DRAINAGE LETTER REPORT

**SHOPS AT MERIDIAN RANCH CONVENIENCE STORE
11810 STAPLETON DRIVE
LOT 2, THE SHOPS FILING NO. 1A AT MERIDIAN RANCH**

**JPS Project No. 092202
PCD Filing No. PPR__**

"PPR2322 and
VR2314"

MHFD-Inlet, Version 5.01 (April 2021)

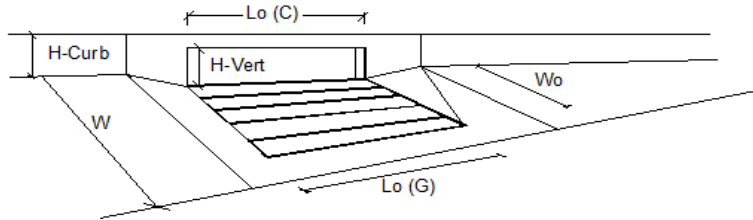
Inlet flow should account for flowby. Use flows from Inlet Mgmt spreadsheet for C1.2 on next sheet.

HORZ. SCALE: 1"=20'	DRAWN: PV
VERT. SCALE: N/A	DESIGNED: JPS
SURVEYED: RIDGELINE	CHECKED: JPS
CREATED: 08/29/22	LAST MODIFIED: 03/31/23
PROJECT NO: 092202	MODIFIED BY: PV
SHEET:	RR-1

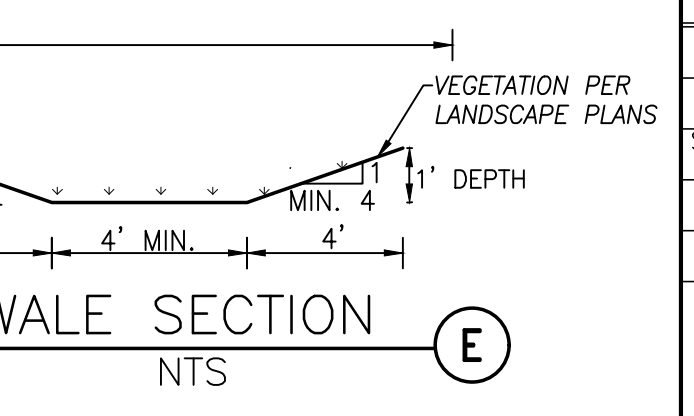
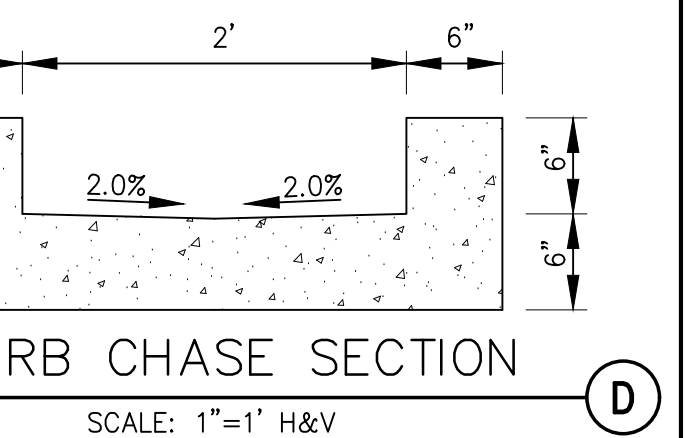
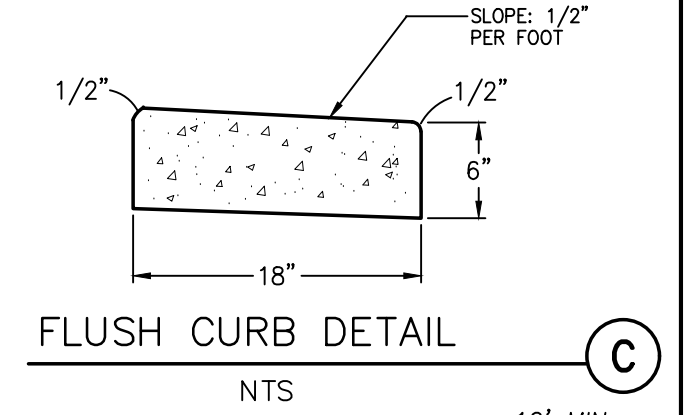
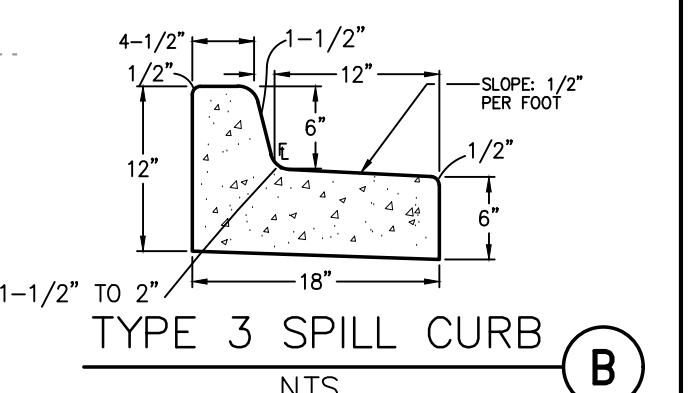
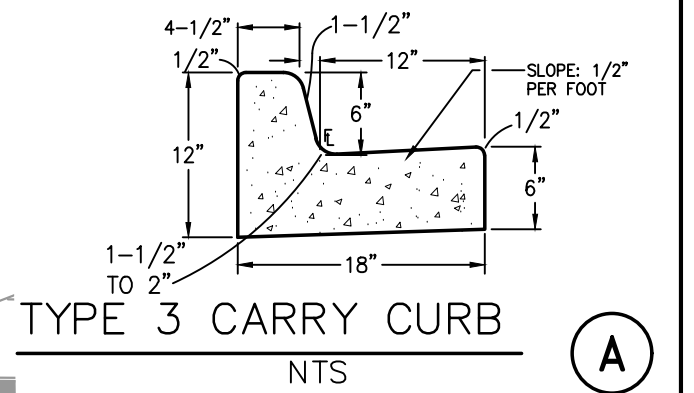
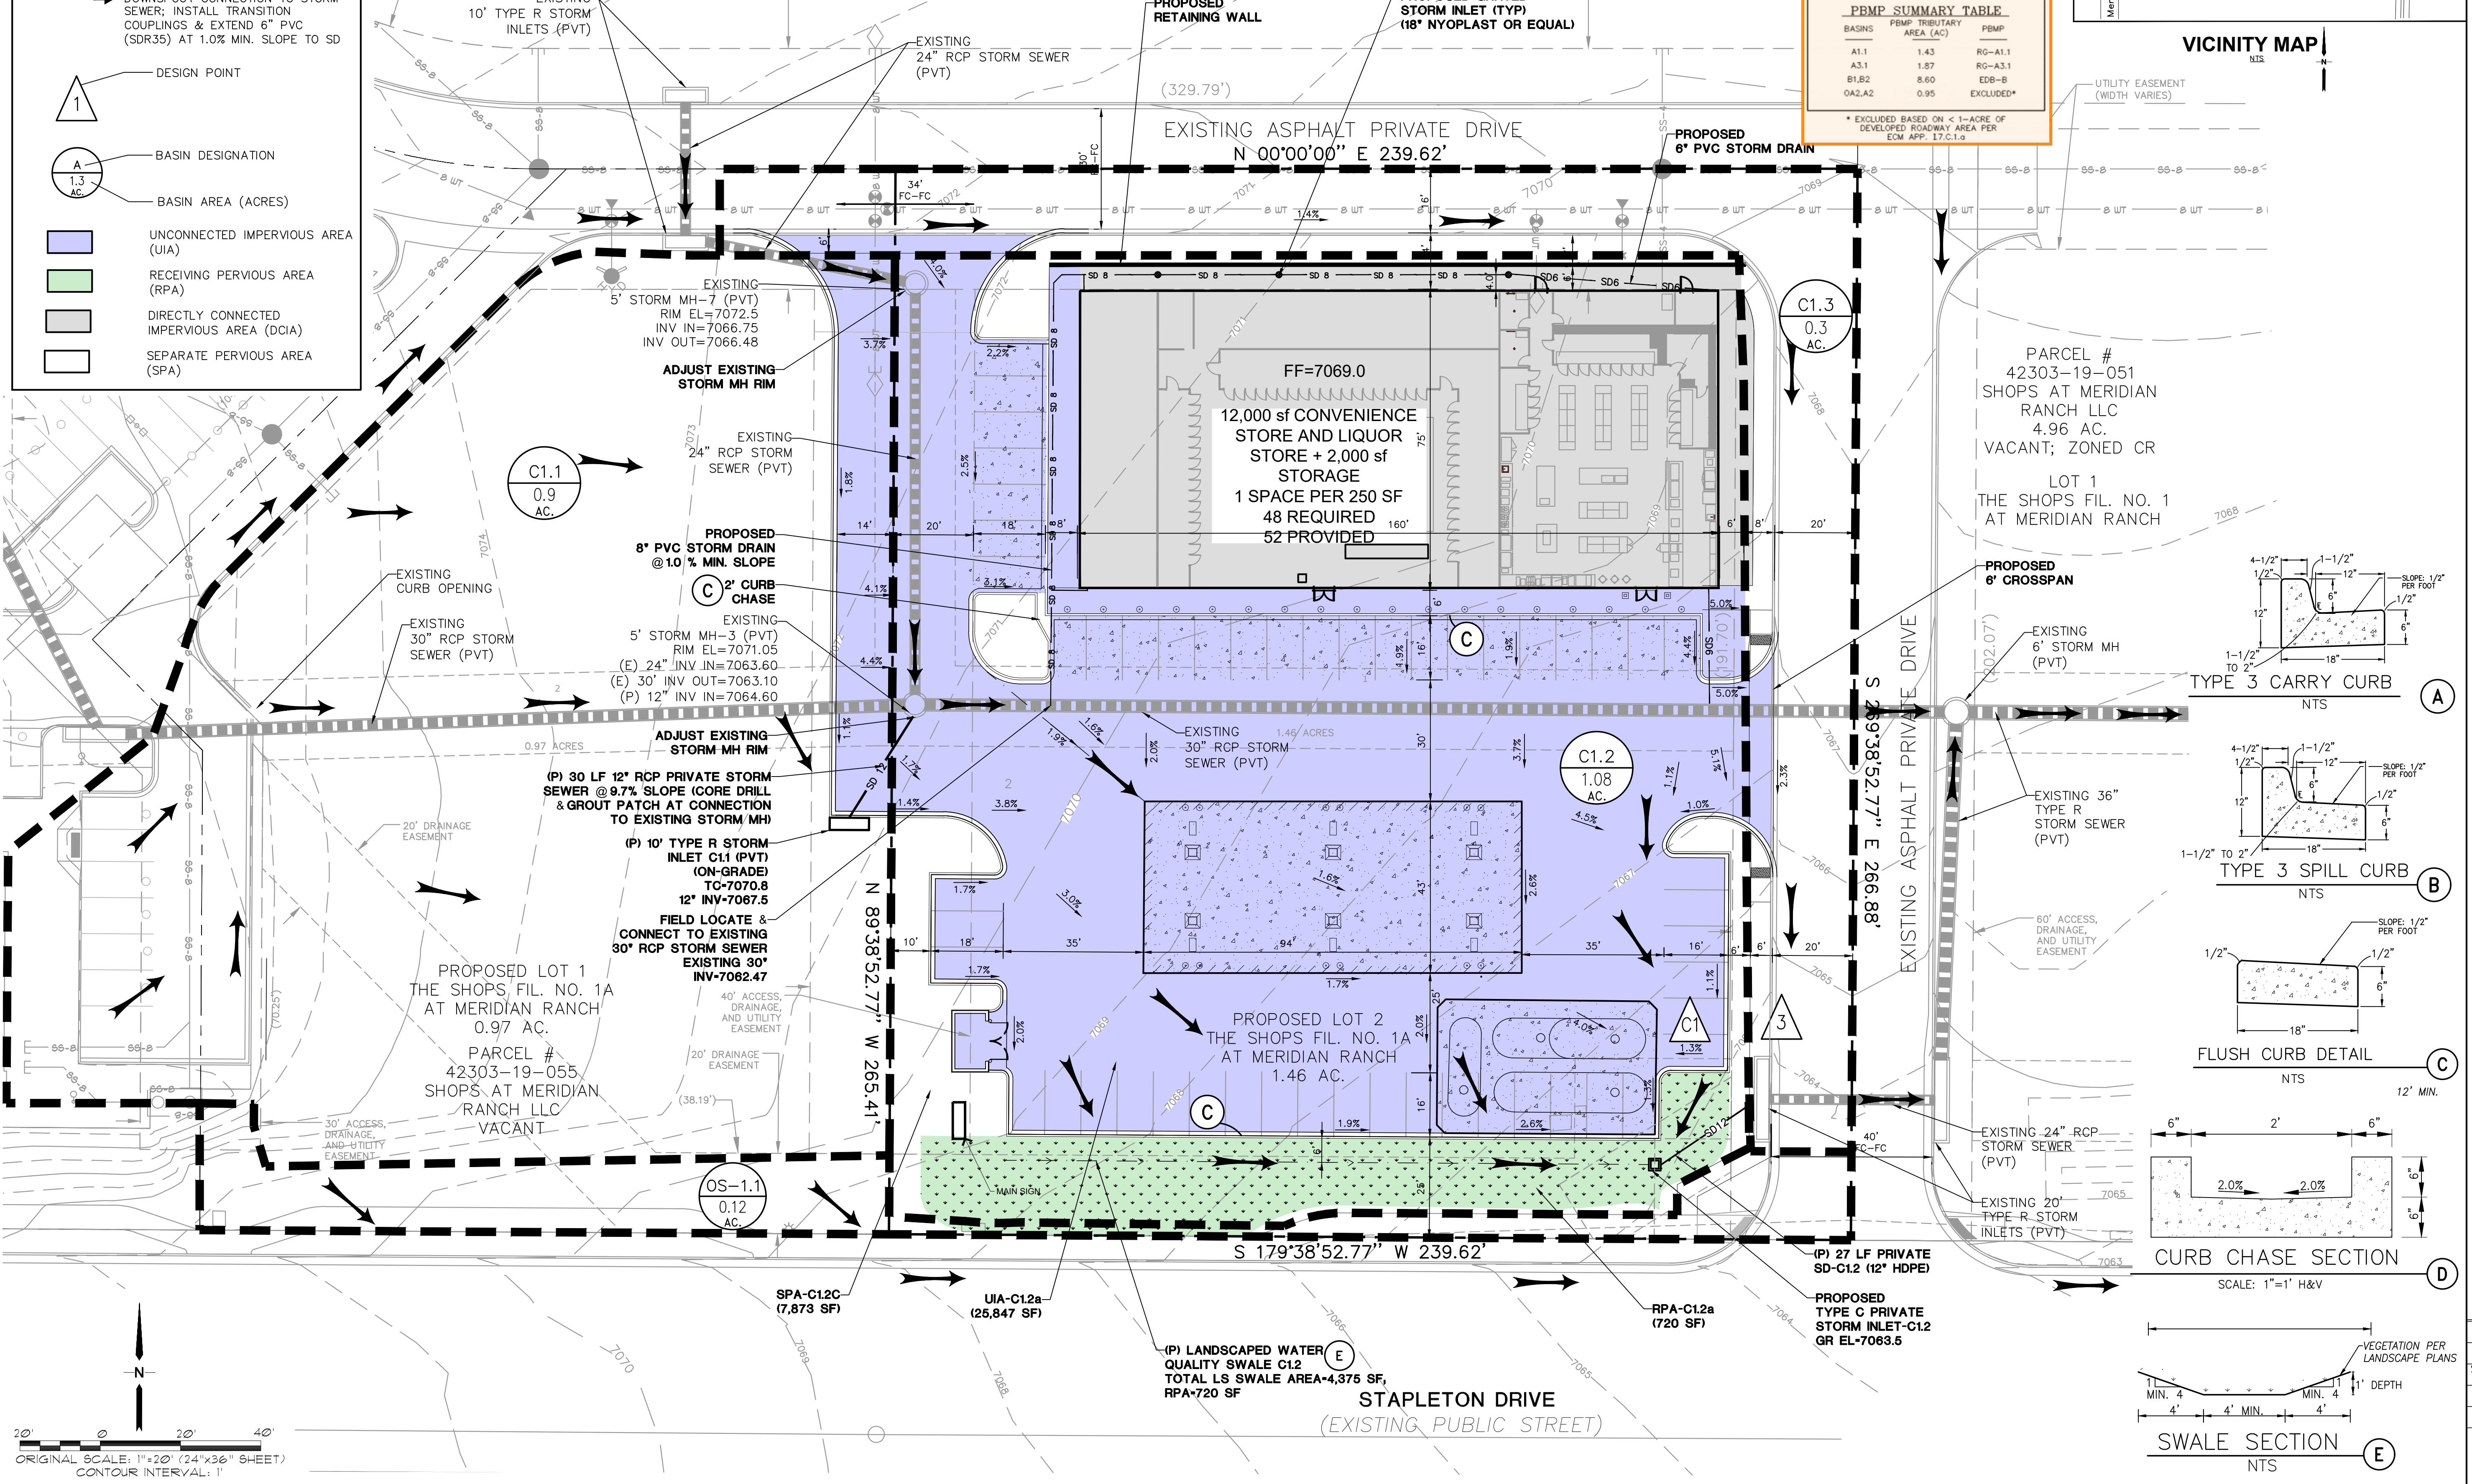
Specific to this site: the map below doesn't show treatment for all areas within the limits of disturbance. Remember that all areas of disturbance need to be accounted for through WQ treatment or an applicable WQ exclusion, not just related to added impervious areas.

And maybe the above spreadsheet is overkill if the entire site is conveyed to and treated by the downstream SNOUT, so a more simply table like the one shown below is better suited. You just need to state that clearly in the text and show that in the drainage map all WQ treatment and exclusions. Your call on how you want to do.

Provide a design point for this inlet (C1.2)

Provide a design point here (C1.1)

Provide basin summary table
